BLUEBIRD STORAGE

SITE PLAN # 17-21

STAFF REPORT #3

PLAN UNDER REVIEW: Non-Residential Site Plan, Bluebird Self Storage, Map 176 Lots 21, 22, & 23, 196-202 Central Street, Hudson, New Hampshire; prepared by Keach-Nordstrom Associates, Inc., 10 Commerce Park North, Suite 3B, Bedford, NH 03110; prepared for Bluebird Self Storage LLC, 125 Ocean Road, Greenland, NH 03840; consisting of 21 sheets with an additional cover page and notes 1-39 on Sheet 1; dated December 20, 2021, last revised February 14, 2022.

DRAINAGE PROFILE
OS#141 TO HW#143
 SCALE: 1" = 40'(HORIZ.)
 1" = 4'(VERT.)

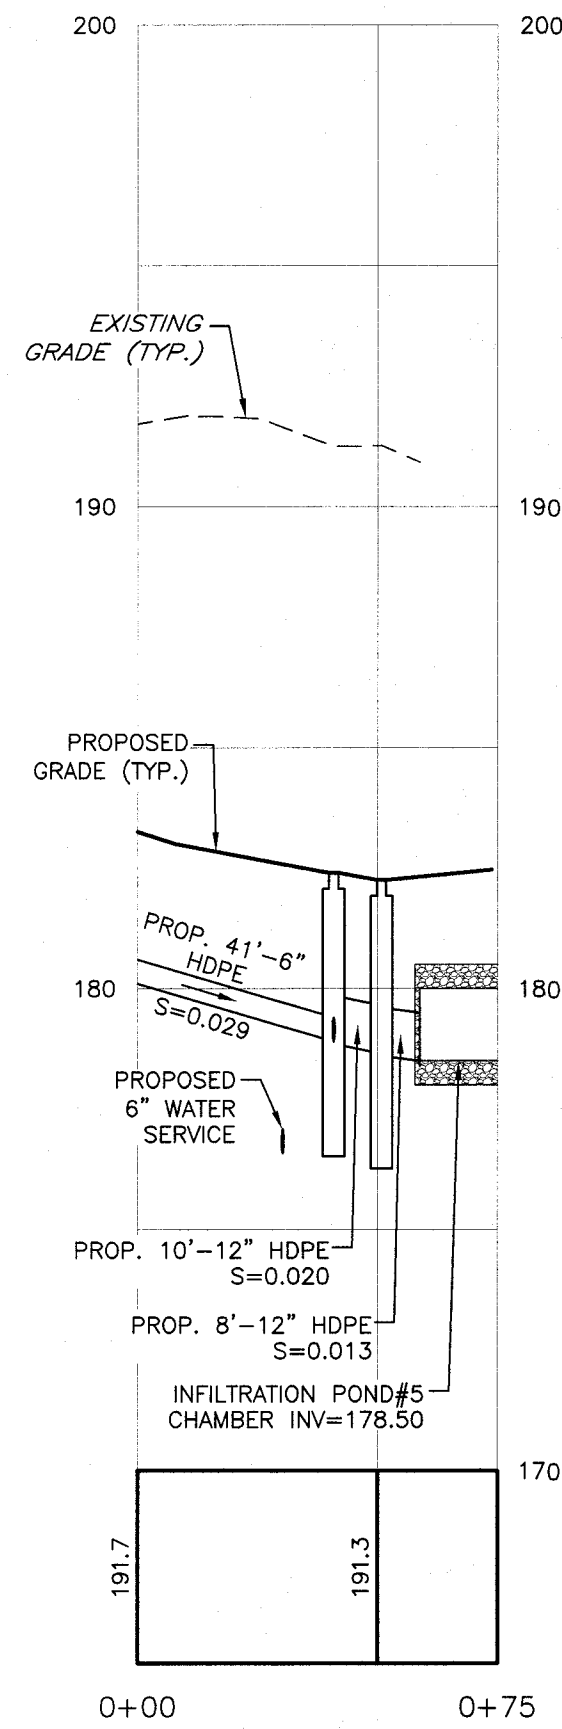
- k. HR 290-6.A.1. The applicant should provide calculations for the sizing of the riprap outlet at HW#143.
- l. HR 290-6.A.9. The applicant should add the required note to the plan set.

- j. HR 290-5.A.12. The applicant should review with the Town if a signed agreement is required.
No comment required.
- k. HR 290-6.A.1. The applicant should provide calculations for the sizing of the riprap outlet at HW#143.
Riprap spreadsheet has been updated.

BIORETENTION POND #2
NOT TO SCALE

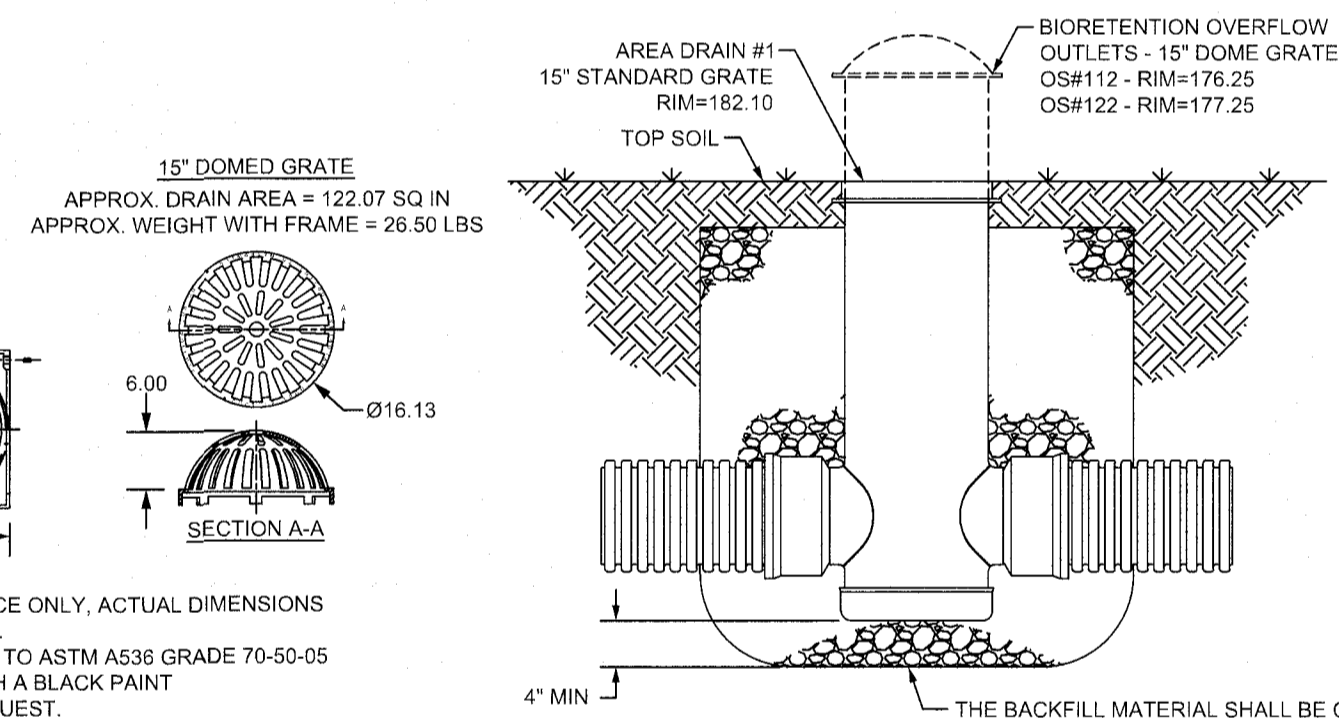
- f. HR 290-5.A.11. The applicant should review the NHDES BMP worksheet for Bioretention Pond #2. The bottom of the filter media course, and the plan sheets noted as containing the filter course specification and plantings appear to be incorrect.
BMP worksheet has been reviewed. The plan sheets have been checked.
